A d d e n d u m

Iowa Department of Transportation
Office of Contracts

B.O.	Proposal ID	Proposal Work Type	County	Project Number	Addendum
007	37-0042-038	BRIDGE NEW - PPCB	GREENE	HDP-004-2(38)--71-37	20DEC007.A01

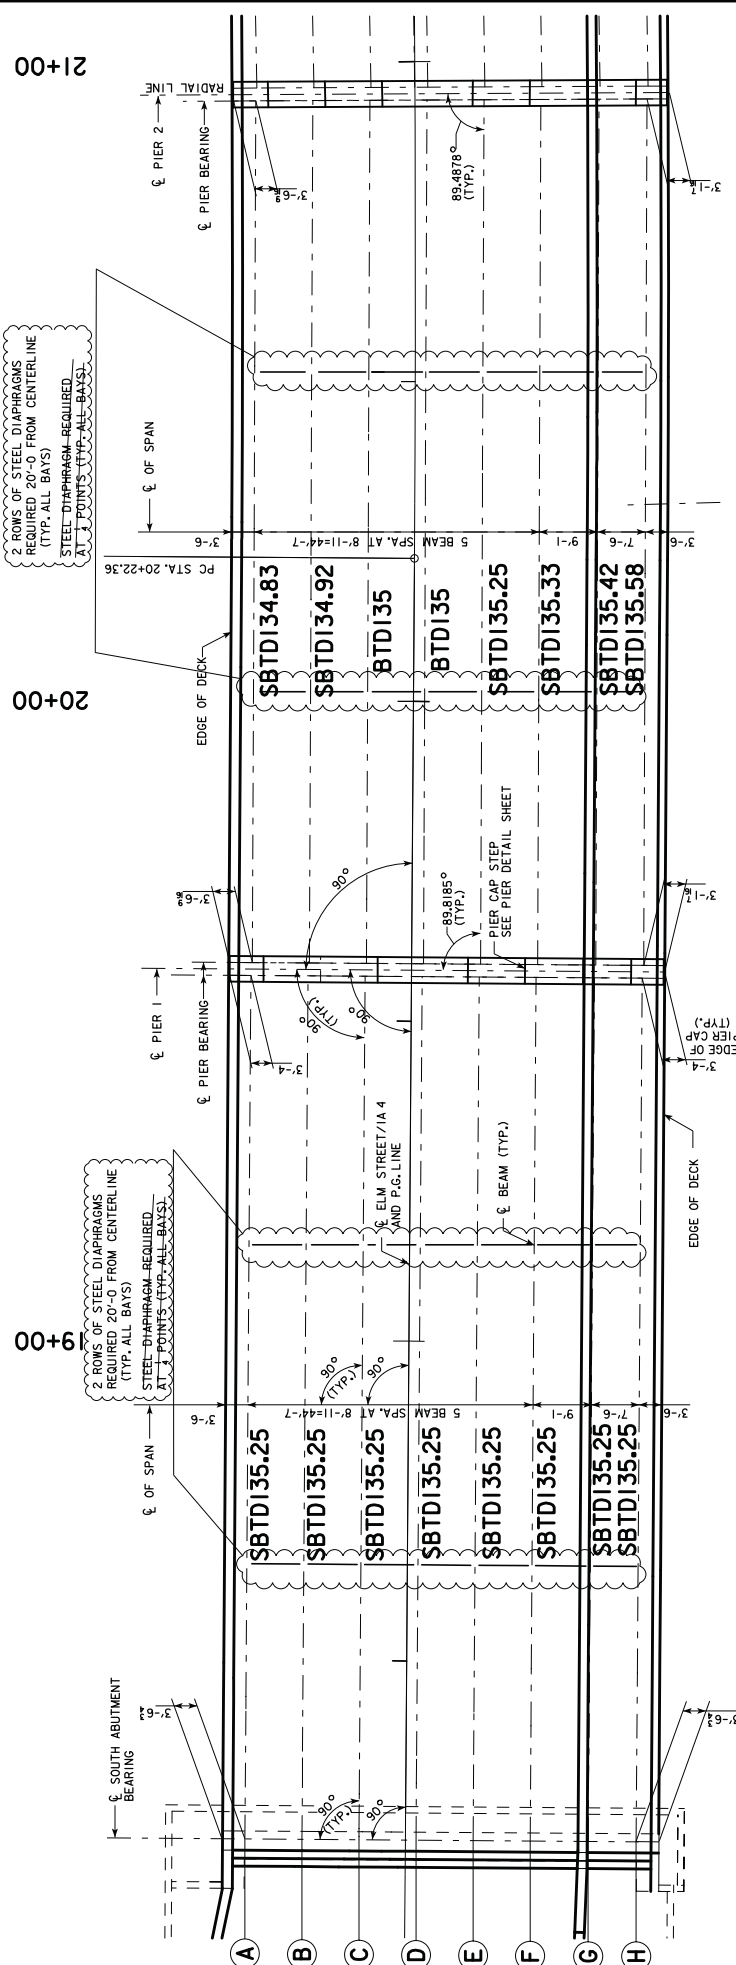
Replace plan sheet numbers 36-39 with the attached plan sheet numbers 36-39.

2 ROWS OF STEEL DIAPHRAGMS
REQUIRED 20'-0" FROM CENTERLINE
(TYP. ALL BAYS)
STEEL DIAPHRAGM REQUIRED
AT ALL POINTS (EVE ALL BAYS)

2 ROWS OF STEEL DIAPHRAGMS
REQUIRED 20'-0" FROM CENTERLINE
(TYP. ALL BAYS)
STEEL DIAPHRAGM REQUIRED
AT ALL POINTS (EVE ALL BAYS)

11-23-2011 REVISED STEEL DIAPHRAGMS, NUMBER OF ROWS & LOCATION

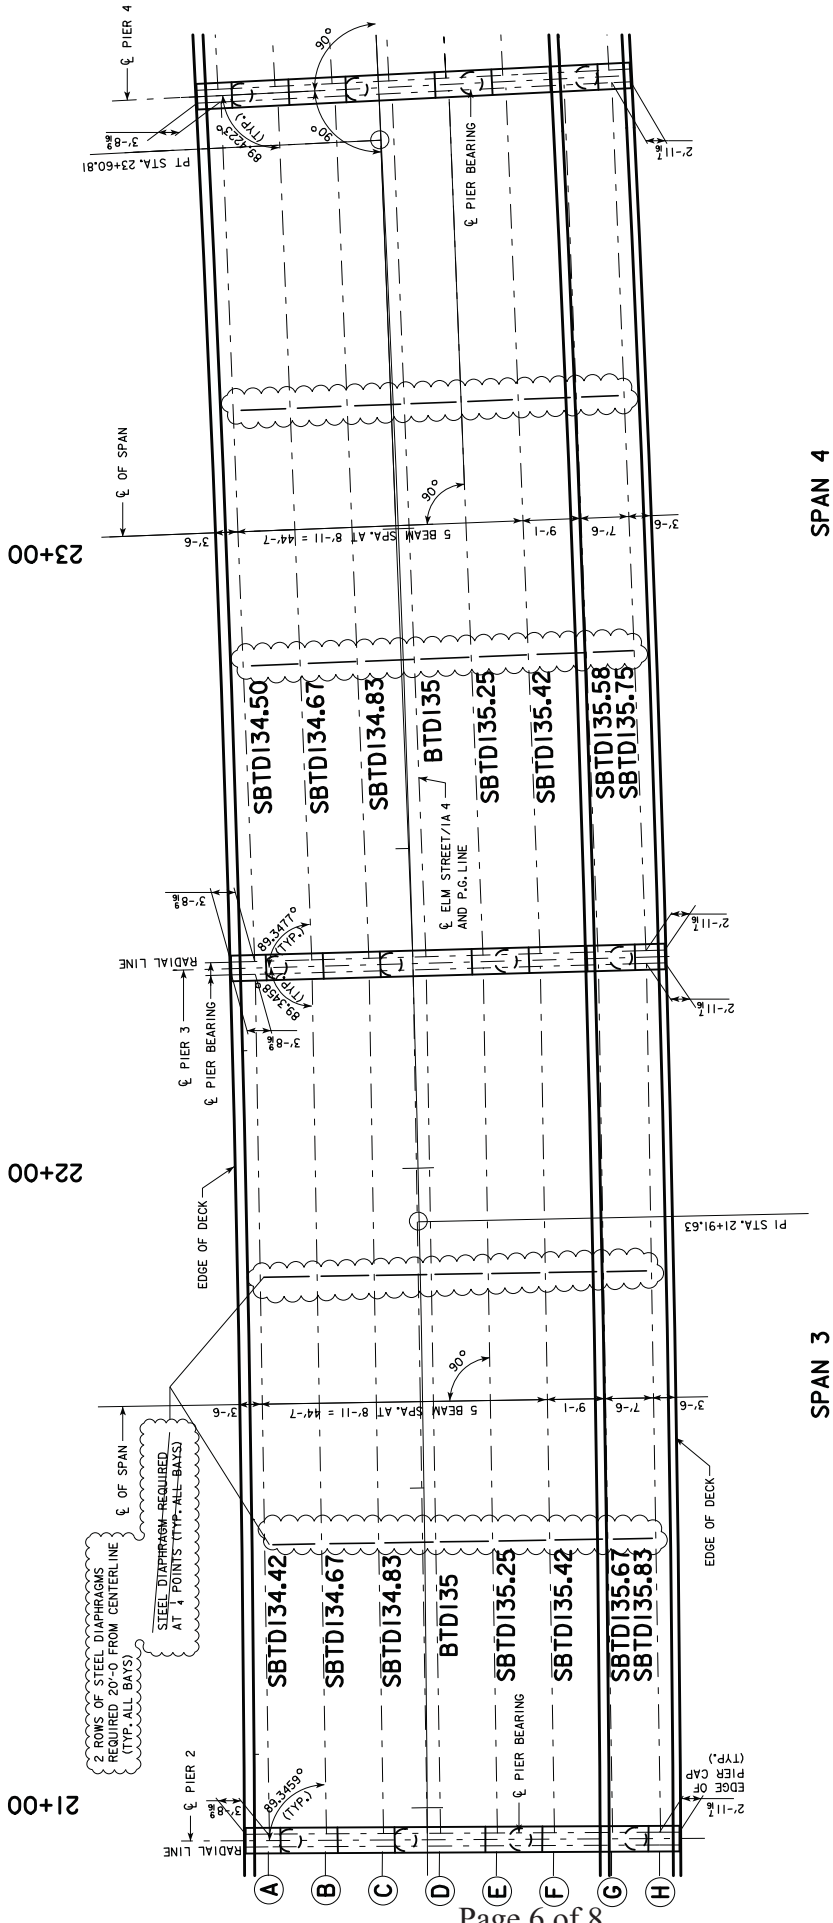
11-23-2011 REVISED STEEL DIAPHRAGMS, NUMBER OF ROWS & LOCATION

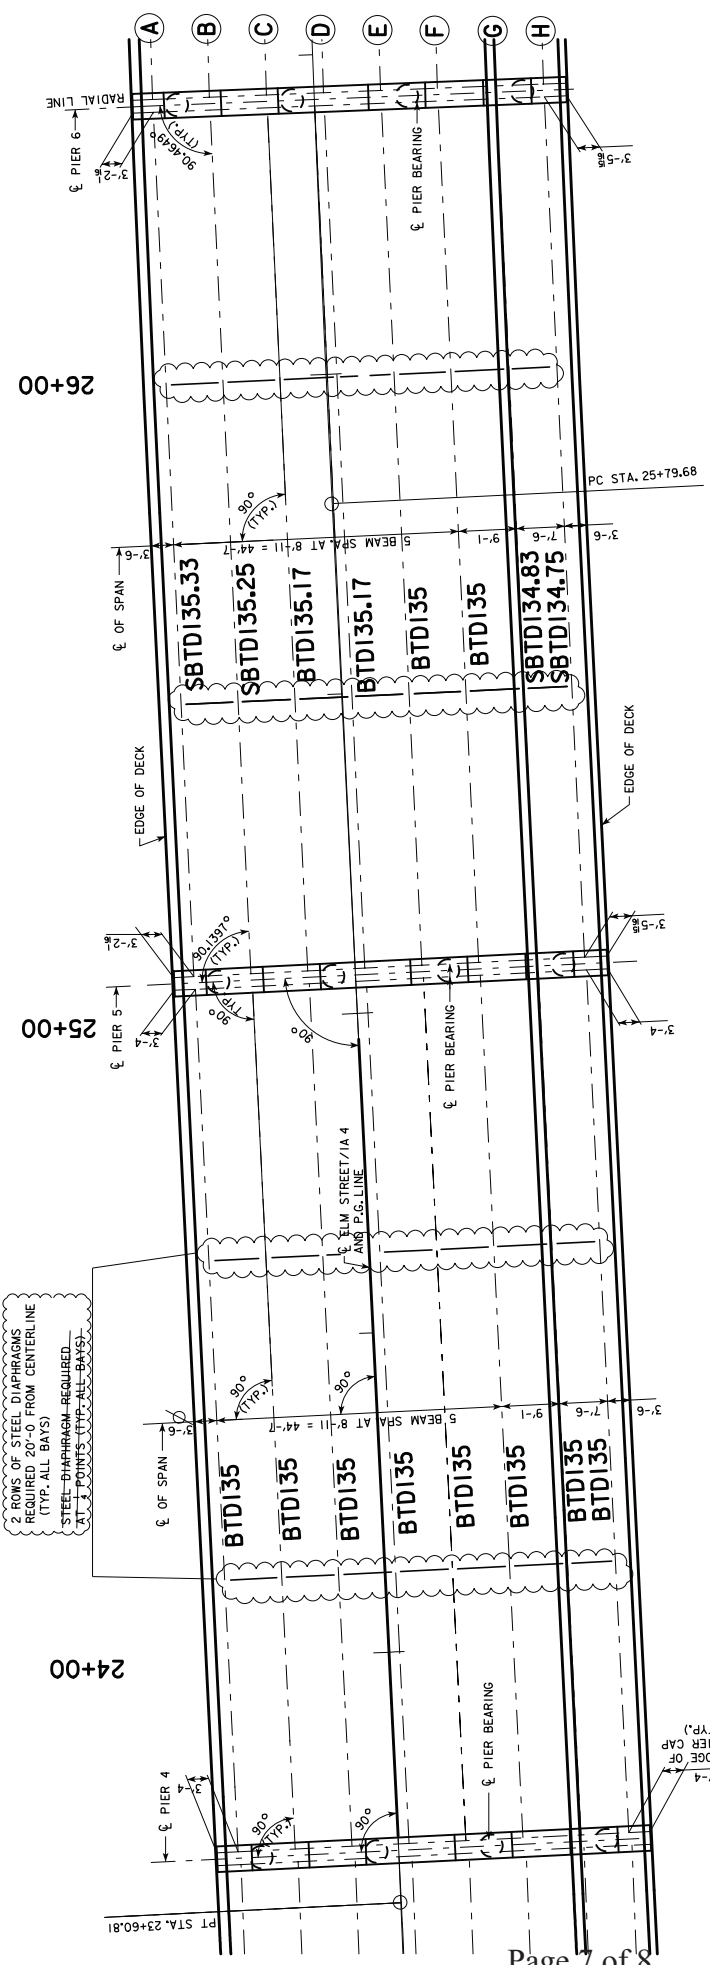
11-23-2011 REVISED STEEL DIAPHRAGMS, NUMBER OF ROWS & LOCATION

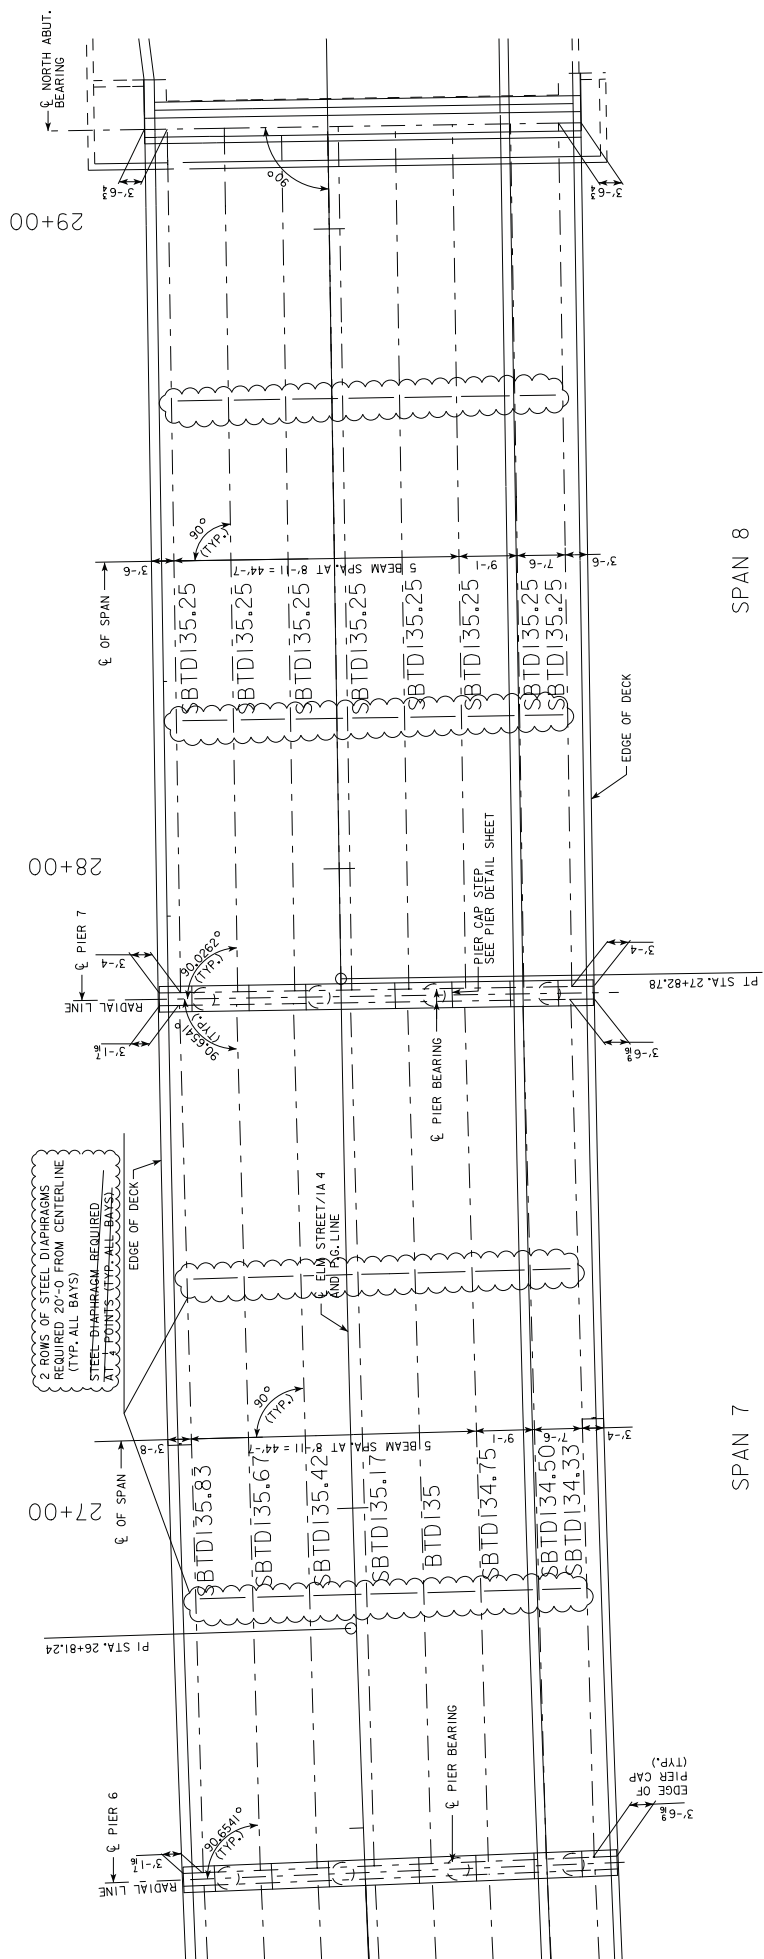
11-23-2011 REVISED STEEL DIAPHRAGMS, NUMBER OF ROWS & LOCATION
